Memo

Date: 12 June 2018

Ref: CT160213

Re: Response to PGL Review Memo Bragg Creek Flood Mitigation Project: Potential Pathways of Effect on Downstream Lands and Waters

SPRINGBANK OFF-STREAM STORAGE PROJECT (SR1) - UTILITY COORDINATION		
DISTANCE BETWEEN BACKWATER EXTENT AND TSUU T'INA NATION BOUNDARY		
SHEET	CONSULTANT DRAWING	TRANSPORTATION DRAWING
1 OF 1	FIG A1	?????-P

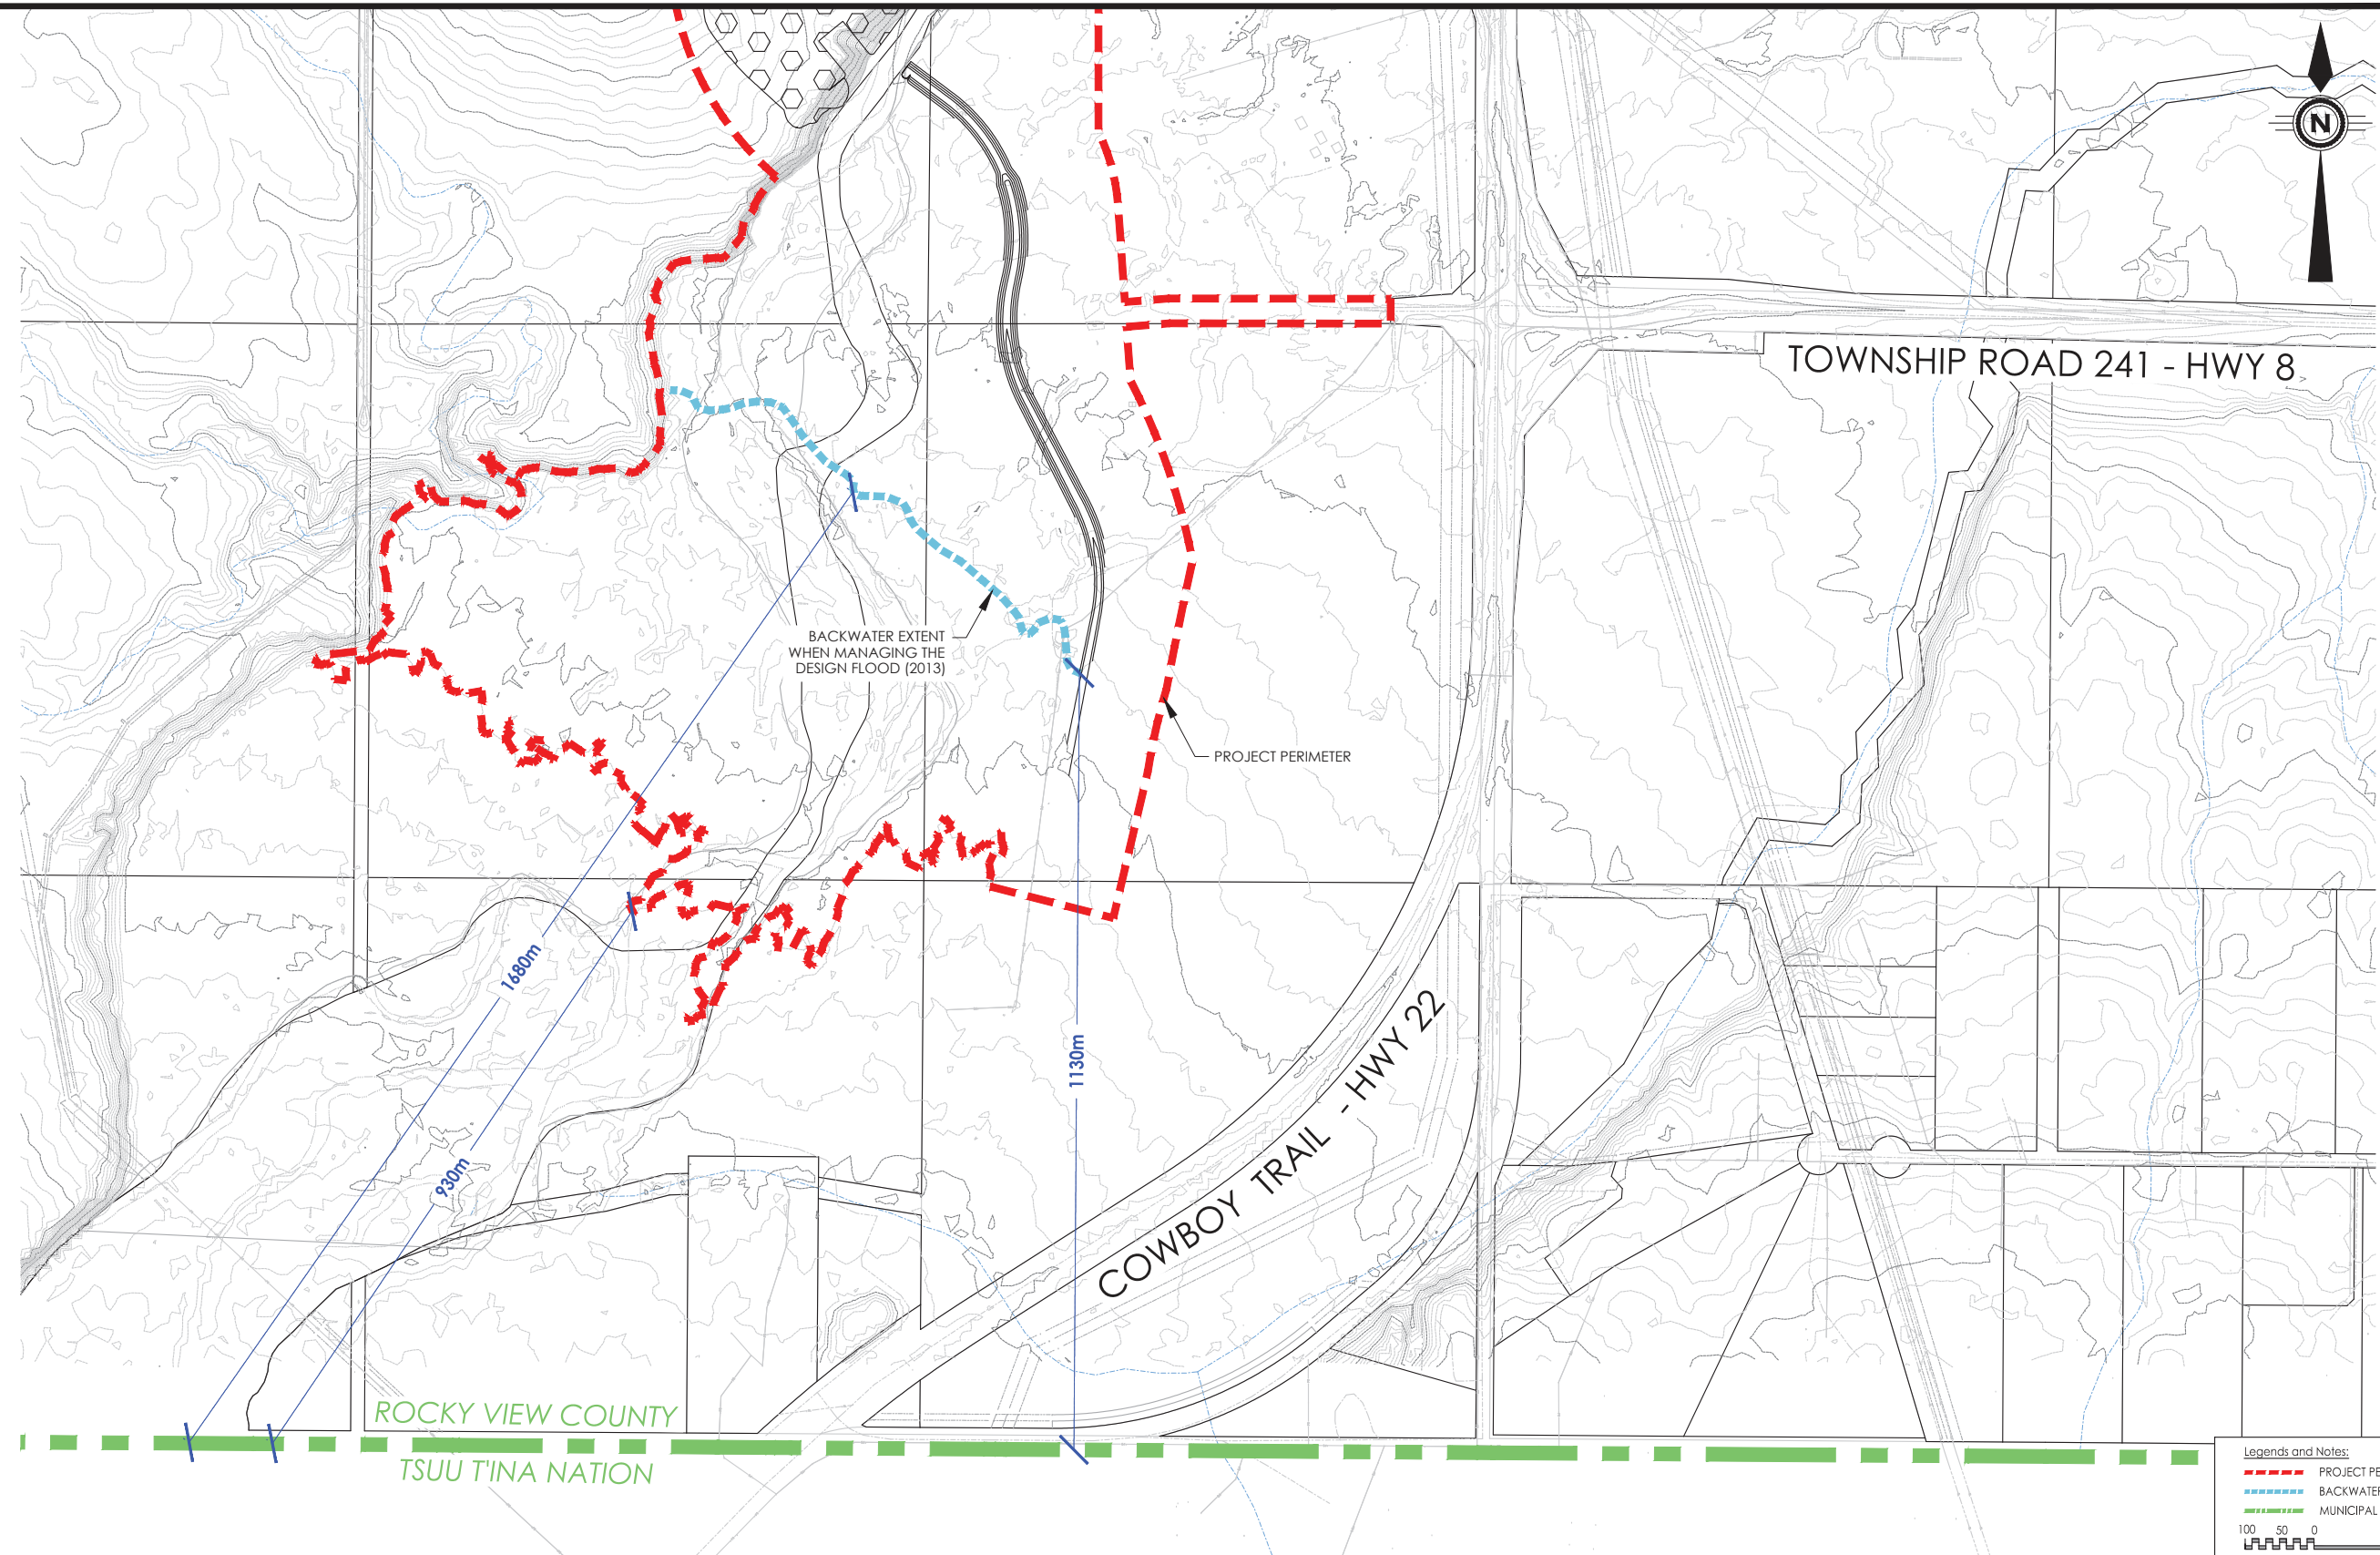
- "As presently written, however, the Design Report does not consider how components of other projects, notably the backwatering required at the proposed diversion structure associated with the Springbank Off-stream Reservoir (SR1) project, may interact with the changes resulting from the Bragg Creek project. The absence of a cumulative effects assessment limits confidence in the conclusion made in the Bragg Creek Design Report that downstream effects are indeed 'relatively minor'."

Appendix A of this Wood response memo contains **Figure A1** obtained from Alberta Transportation (AT) that shows that the distance between the backwater extent of SR1 and the north Tsuut'ina boundary is 1,680 m (as measured along the channel, the distance is 1,130 m measured due south from the backwater to the Tsuut'ina boundary). There is no interaction between the two projects given that: (1) the impacts due to the Bragg Creek Flood Mitigation Project at Redwood Meadows are negligible; (2) the backwater extents of SR1 are 1,680 m downstream of the north Tsuut'ina boundary. Additionally, as can be seen in **Figure A2** of **Appendix A**, the difference in stream bed elevation (i.e. the vertical drop) between the backwater extent of SR1 and the Hamlet/Tsuut'ina boundary is 72.9 m and the horizontal (measured along the channel) distance is 9.5 km. Hence, there is no possible interaction between the water levels of the two projects.
